RAMP REPORT REGION 2 ADA 2026

Lawerence St., & Ingraham Lane,
Rockland

New Ramp # Marketplace

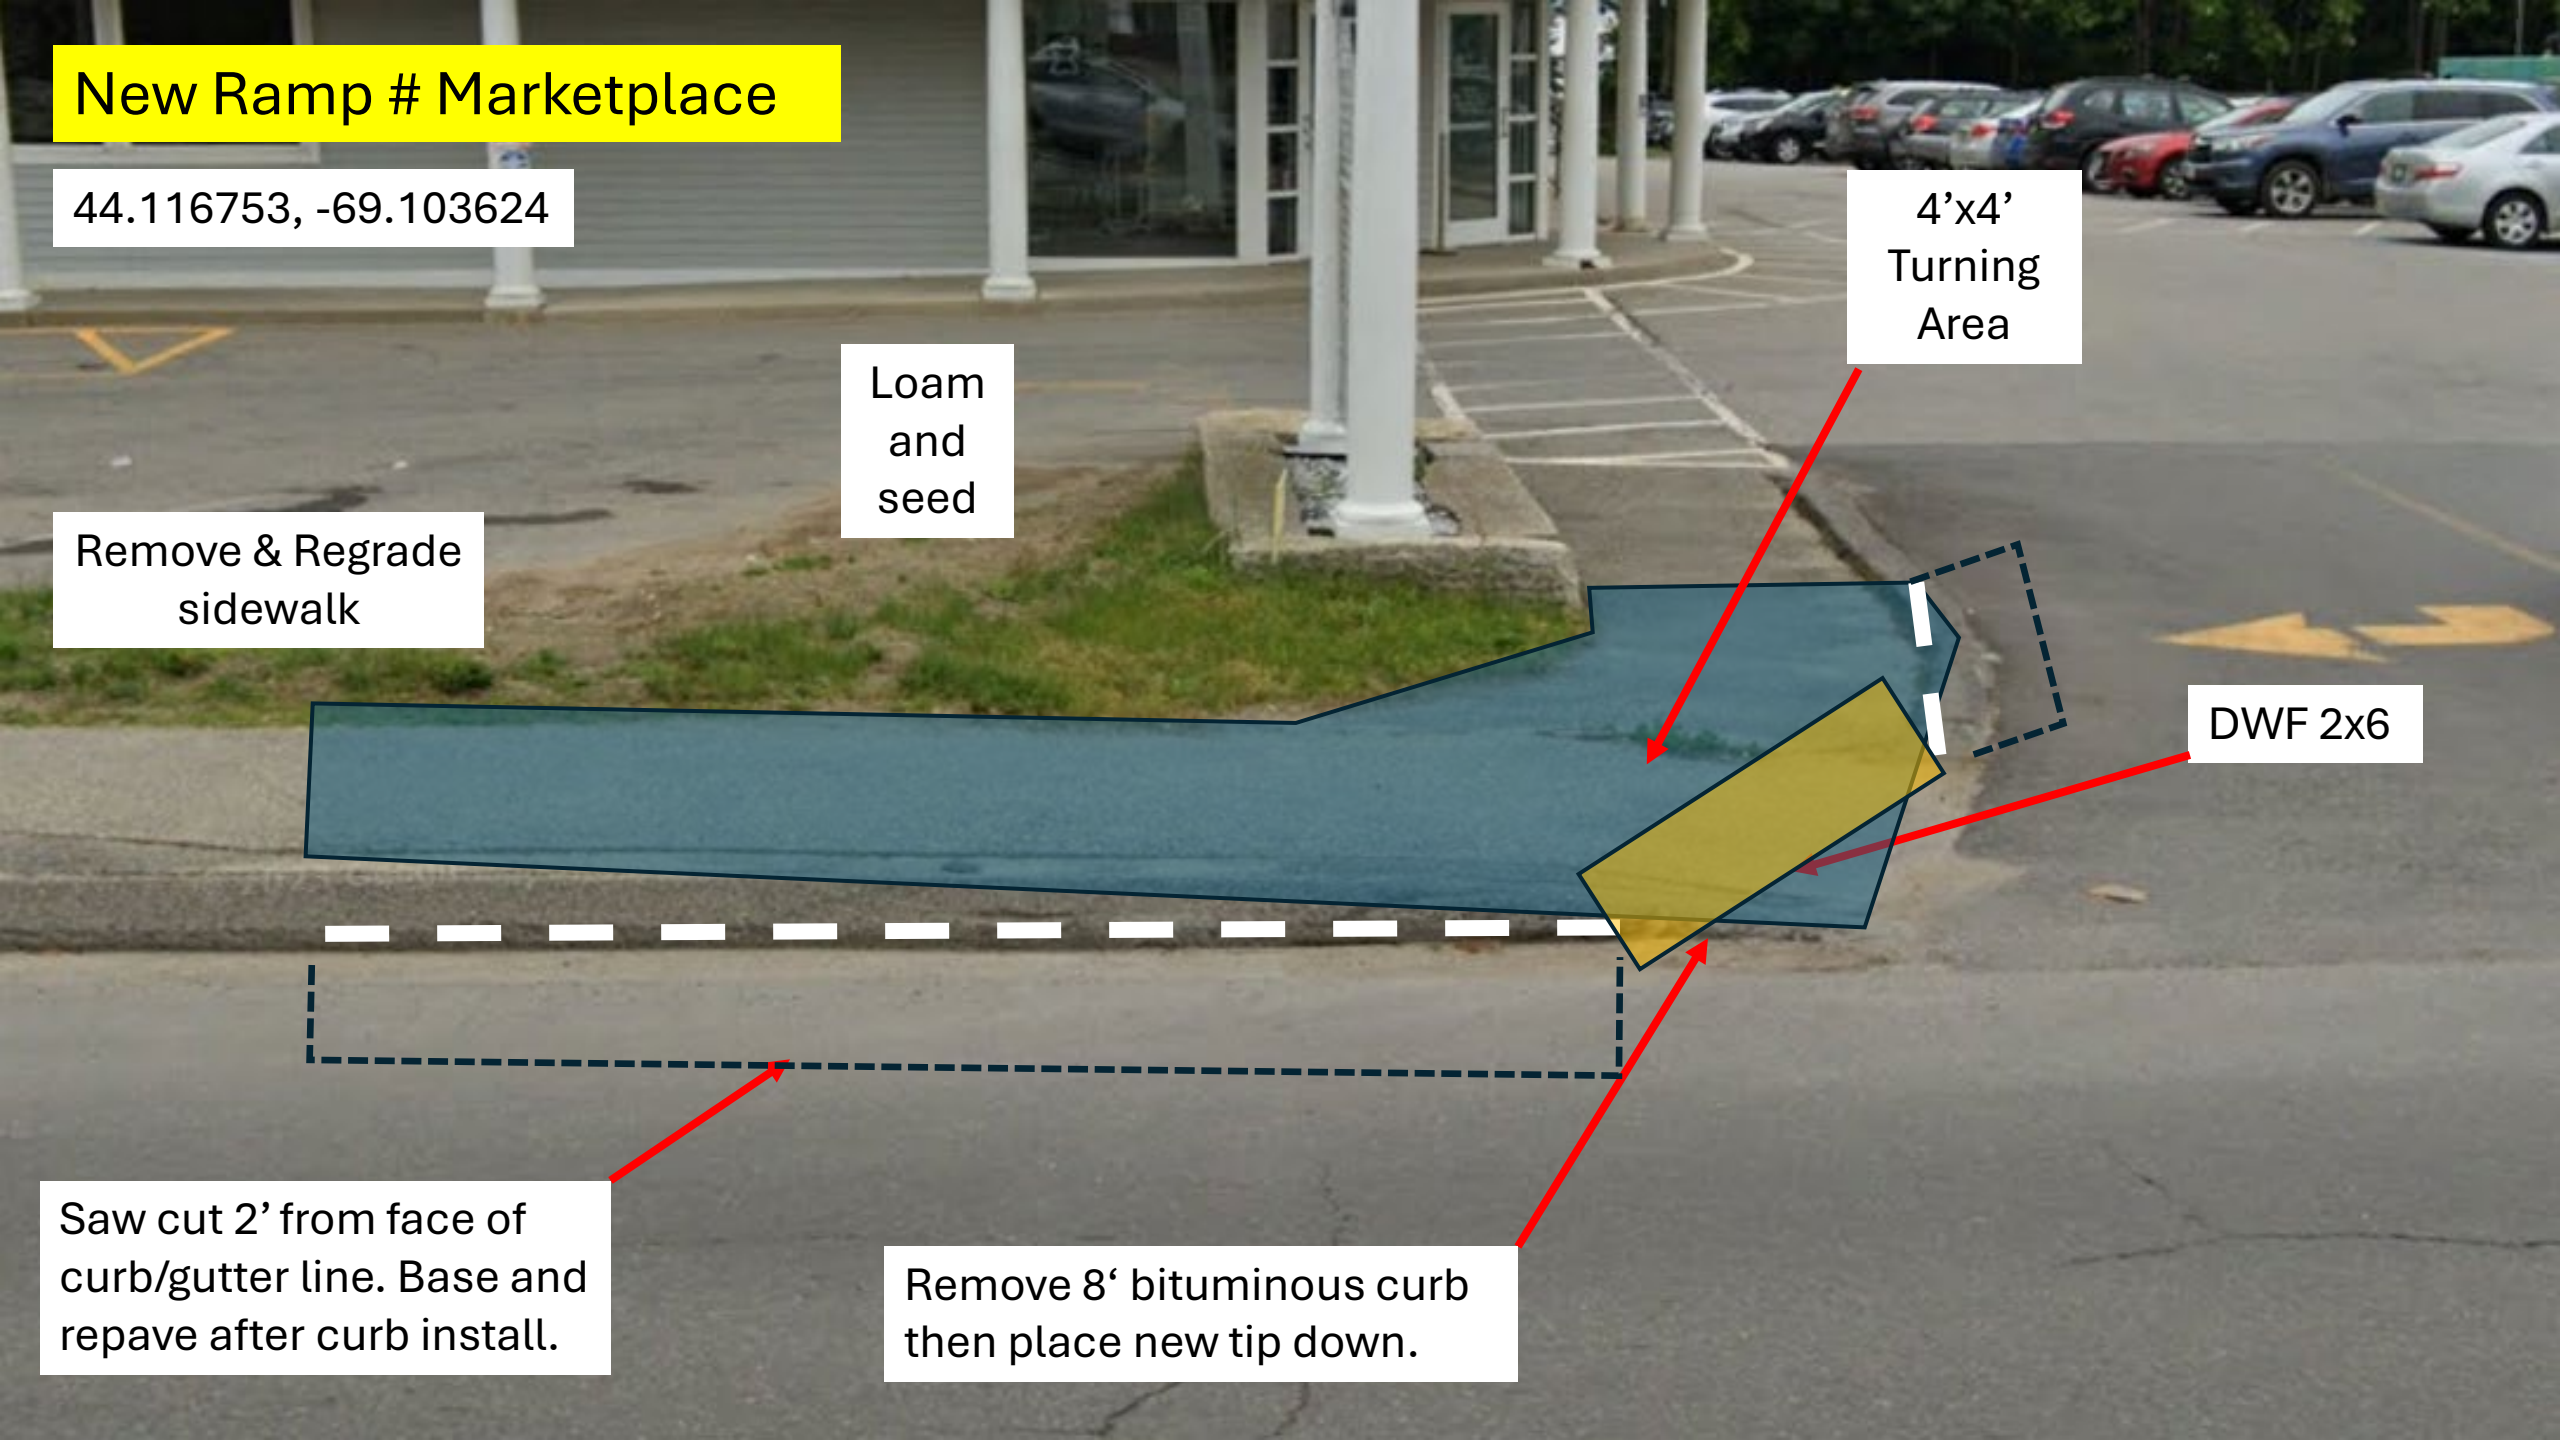
Loam
and
seed

Remove & Regrade
sidewalk

4'x4'
Turning
Area

DWF 2x6

Saw cut 2' from face of
curb/gutter line. Base and
repave after curb install.

Remove 8' bituminous curb
then place new tip down.
